**Project #20-021  
Truck Ranch  
Located at 1200 S Main Street**

*Project Name:* Truck Ranch  
*Proponent / Owner:* Julie Henry / Wagscap LLC  
*Project Address:* 1200 S Main Street  
*Request:* Design Review and Conditional Use Permit  
*Current Zoning:* Commercial (COM)  
*Type of Action:* Quasi-Judicial  
*Hearing Date:* April 9, 2020  
*Submitted By:* Aaron Smith, Planner II

Staff Report for the Planning Commission meeting of April 9, 2020

**SITE PLAN**  
**TRUCK RANCH LOGAN**  
LOGAN, CACHE COUNTY, UTAH

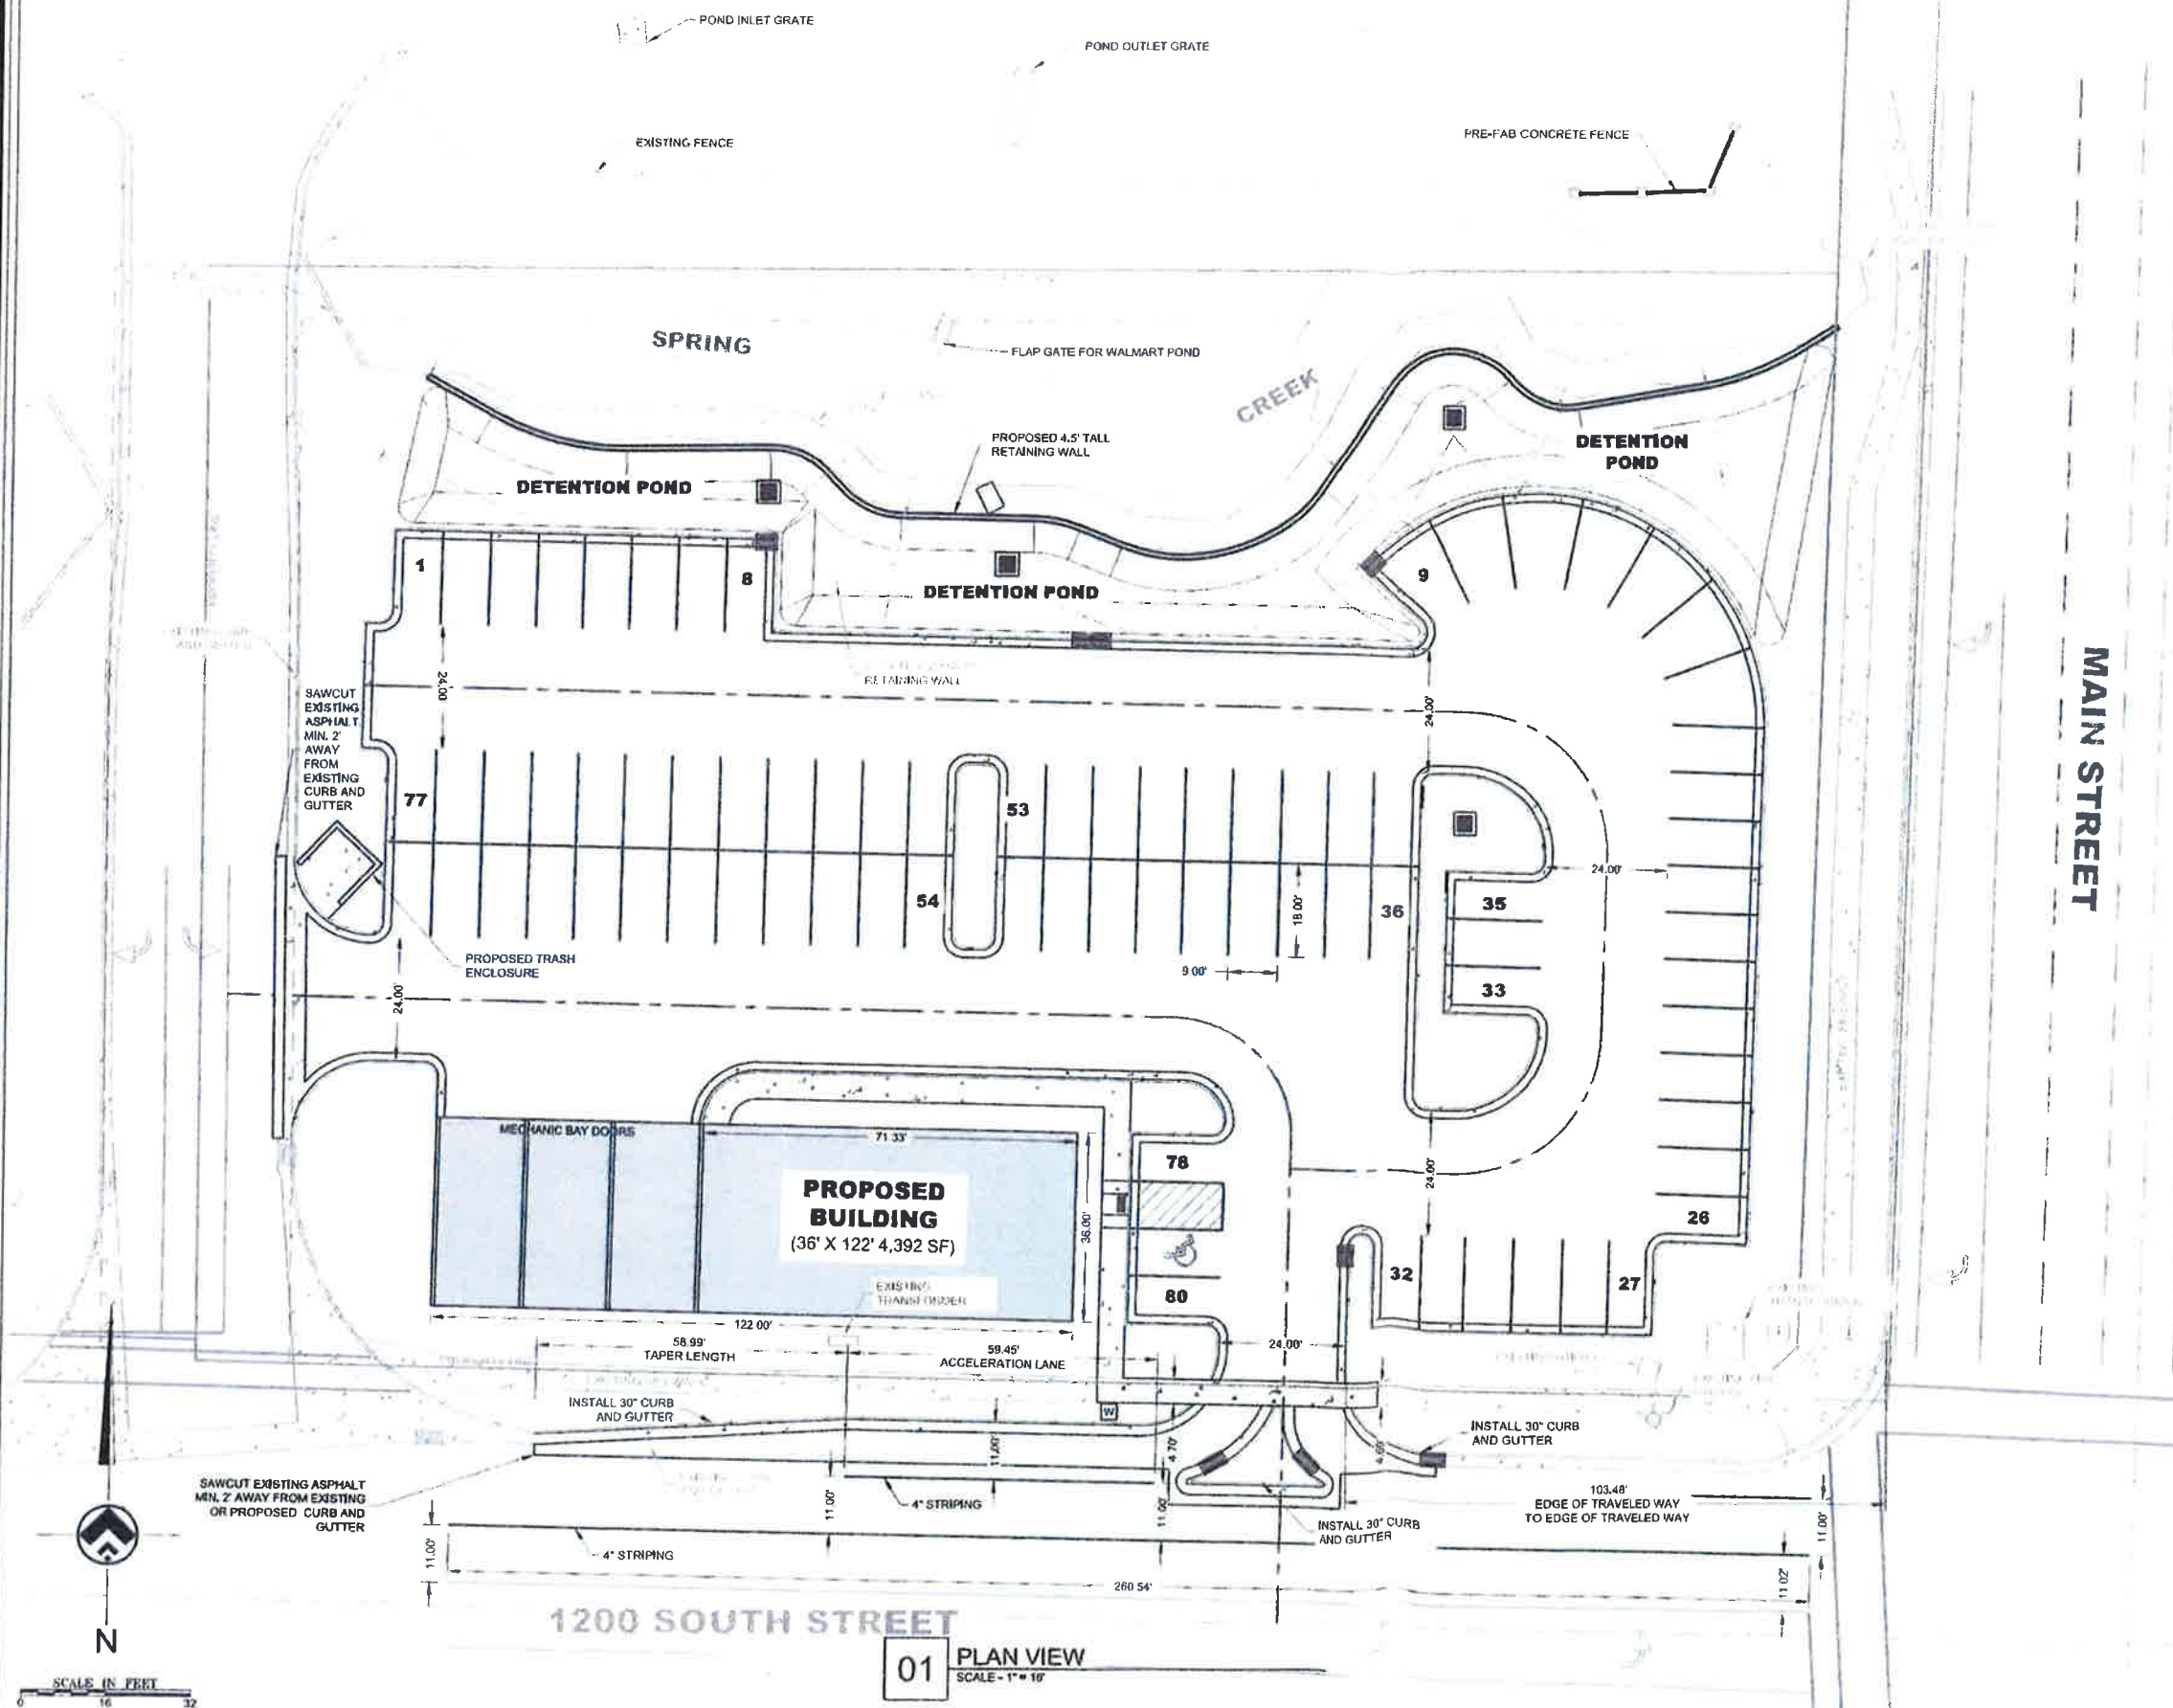
The LDC regulates building orientation and entries for commercial development. The standards state that where feasible, corner buildings with two frontages shall have the primary entrance oriented to the street corner. The proposed building is placed away from the corner along the 1200 S frontage. Ideally, the building would be placed near the corner so that the building has a presence on both street frontages and addresses the corner. Due to environmental constraints on the site, the long portion of the building cannot be oriented towards Main Street. Staff recommends that the building be placed closer to the corner to provide building mass along both frontages. While the placement and building mass will not fully comply with minimum frontage requirements, considering the constraints of the site, the placement will improve the urban form of the development. Draft floodplain maps provided by the applicant show that the southeast corner of the site is not in the floodplain and is at a similar elevation as the proposed location.

As automobile sales requires a Conditional Use Permit, the placement of the building near the intersection will help to alleviate impacts that may be associated with the use, namely, the placement of parking along the primary corridor. The building being moved will help to buffer this impact and create a more cohesive urban form. As conditioned, with permitting 46% building frontage and the building placed between 10'-30' behind the sidewalk along the Main Street frontage, the project complies with the requirements in the LDC.

Shifting the building would affect the east setback and reduce it to between 10'-30'. The shift would increase the west side setback. As proposed, the project complies with the requirements in the LDC.

The proposed layout places parking predominately along the Main Street corridor. The condition to place the building at the corner will help to alleviate the visual impact of the parking along Main Street and instead make the building the primary focus. Shifting the building will impact the parking configuration and may reduce total parking stalls for the site. As conditioned, the project complies with the requirements in the LDC.

The primary impactful consideration for this project is the location of the building. As a Conditional Use in this zone, conditions may be placed on the use to mitigate negative impacts. For this project, due to its high visibility on the corner of South Main Street, staff recommends placing the building along the Main Street frontage to improve the building mass along the primary frontage. While site constraints do not permit the long portion of the building to be fronted along Main Street, some building mass will improve the aesthetics of the corridor and reduce the impact of parking being placed primarily along the frontage. Moving the building will force design changes to the proposal, including the likely elimination of the second access onto 1200 S and the parking configuration.

3. The building shall be placed 10'-30' from the back of the sidewalk along the Main Street frontage to provide building mass along Main Street.
4. A minimum of 6 customer parking stalls are required on site.

PERSPECTIVE  
ELEVATIONS

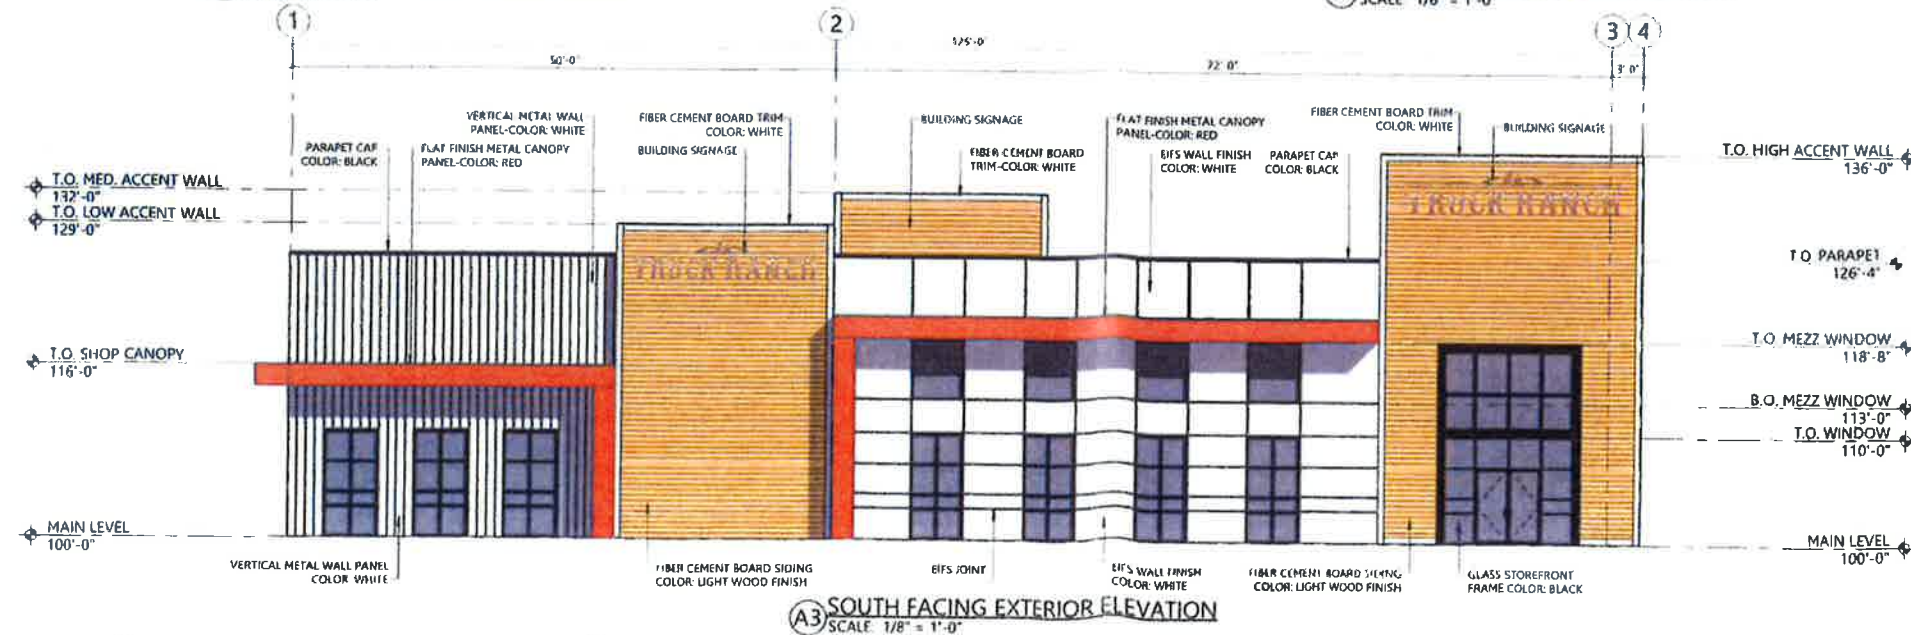
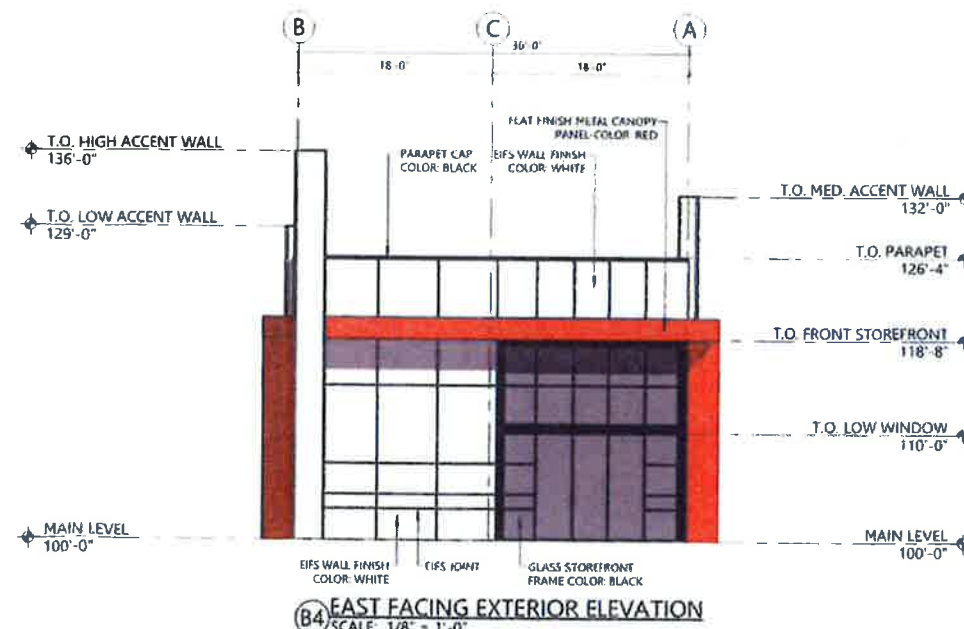
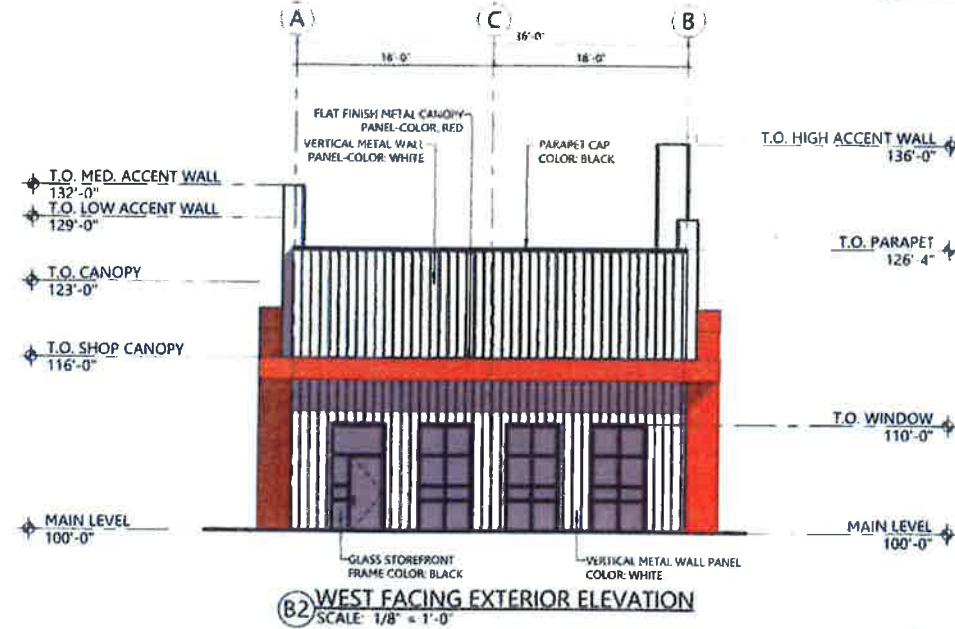
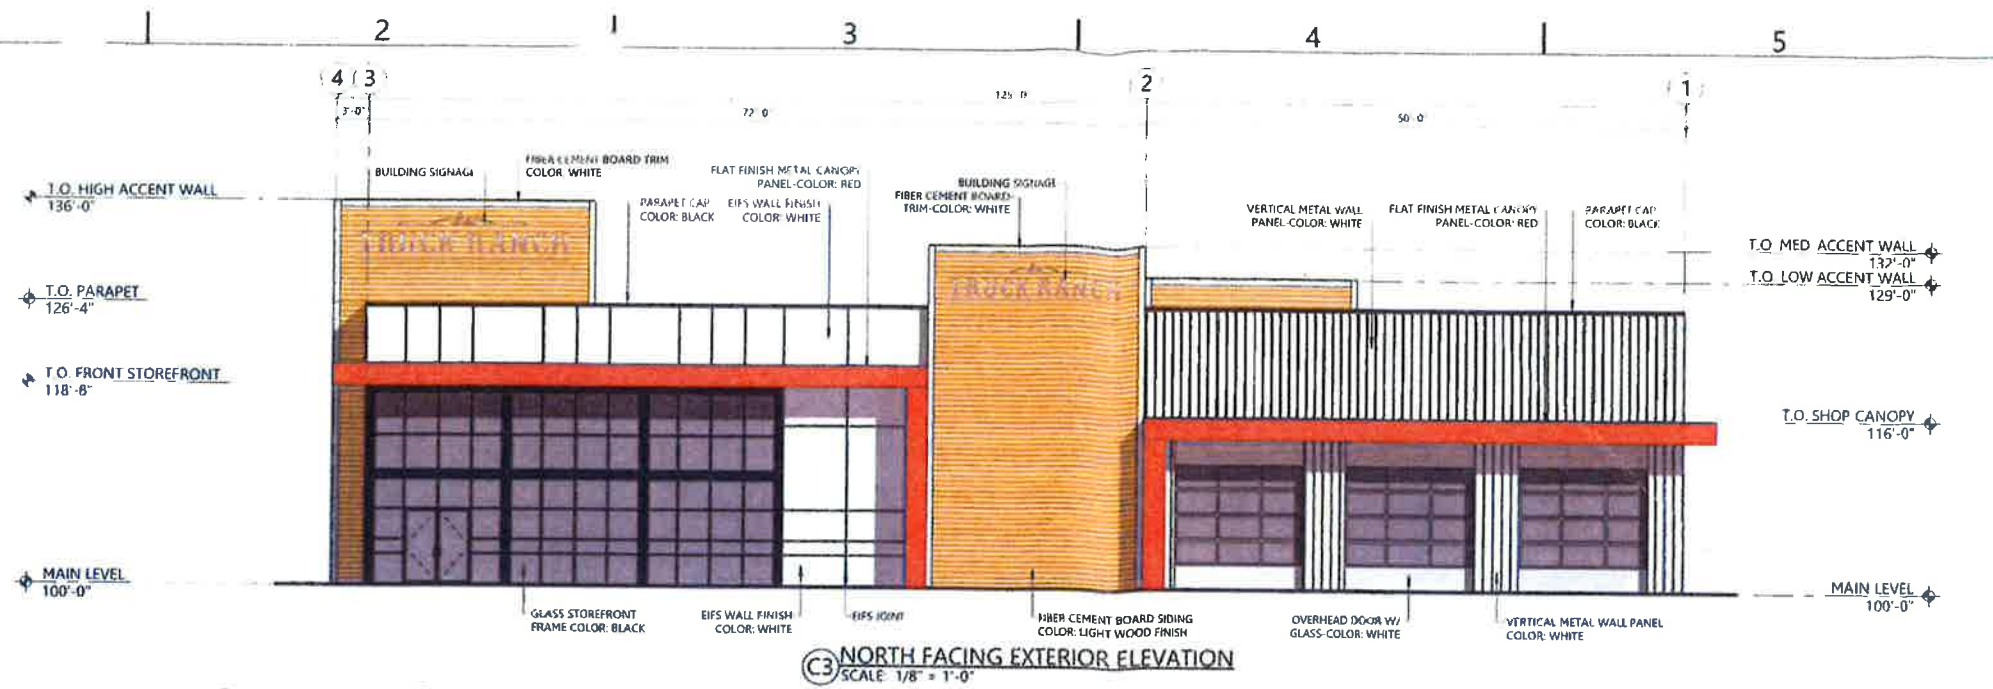
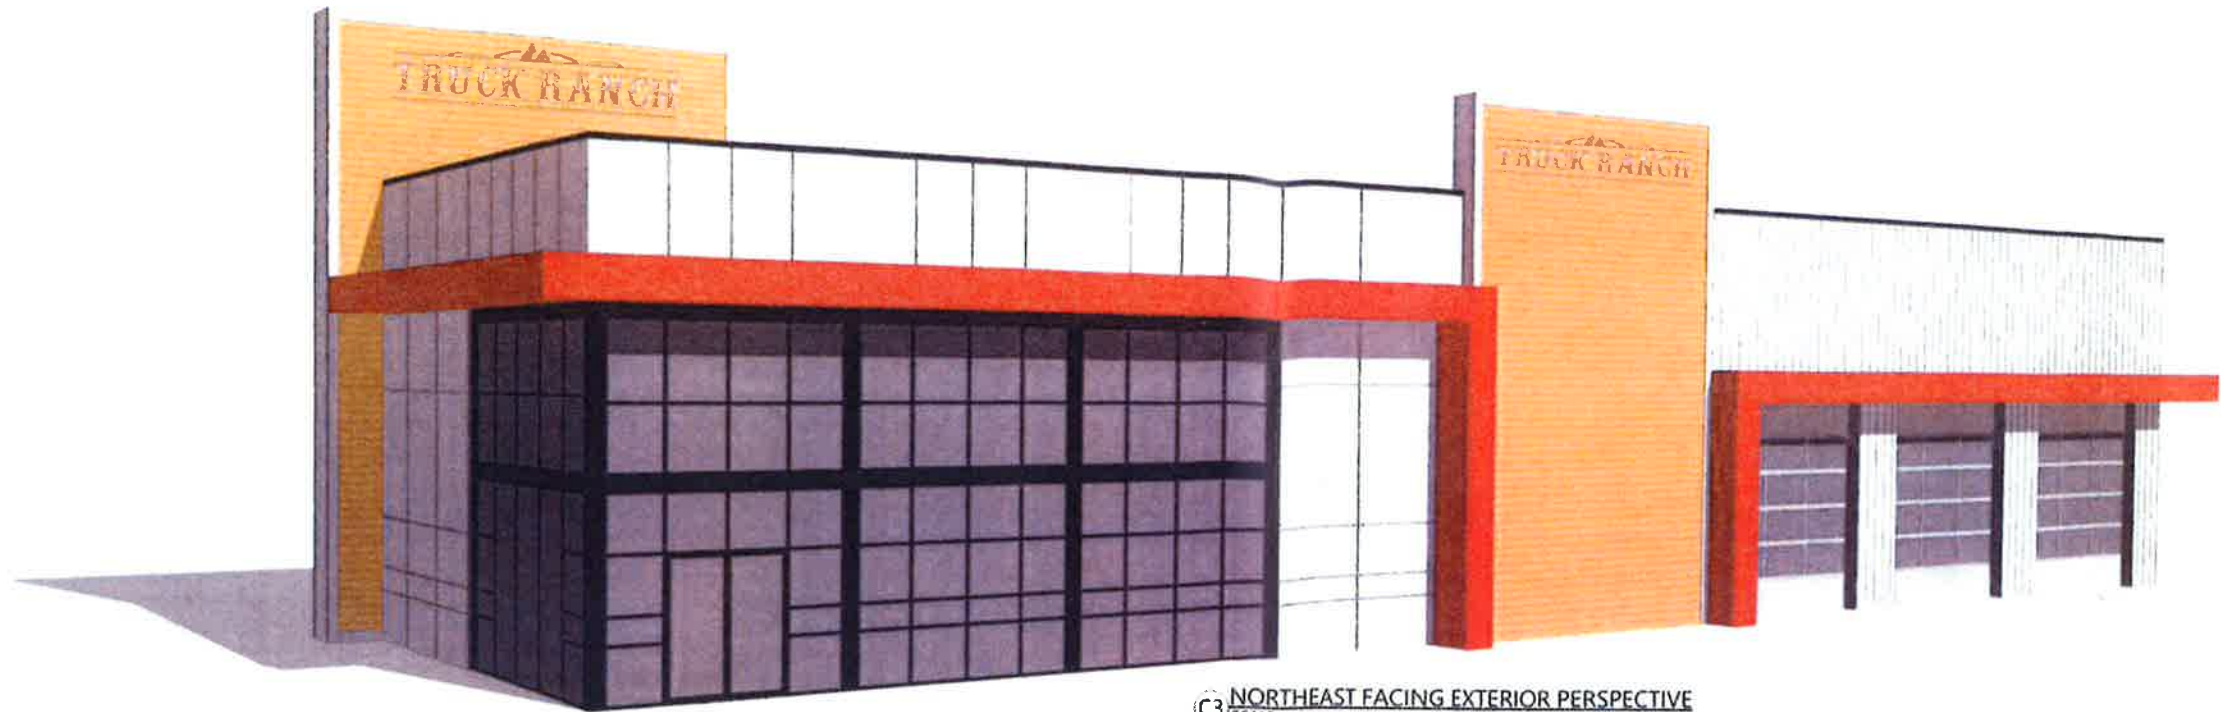
The LDC states that commercial buildings should be designed to promote high-quality and aesthetically pleasing developments. The design standards consider building variation, materials, building mass, articulation, roof, placement, and orientation. The standards emphasize 4-sided architecture. The proposed building is oriented with its primary entrance the interior parking area. While the building is not oriented towards the street, the building features architectural detailing and fenestration on all four sides. The proposed building is broken up into section less than 40' in length through window placement changes in wall plane, material changes, and articulation of the roofline. The building materials include fiber cement board, metal, and stucco. The proposed building has a flat roof and it is 26' 4" to the top of the parapet, and 36' tall at the top of the accent walls.

South Elevation (Frontage):	31%
East Elevation (Exposed side):	47%
North Elevation (Exposed side):	45%
West Elevation (Exposed side):	30%
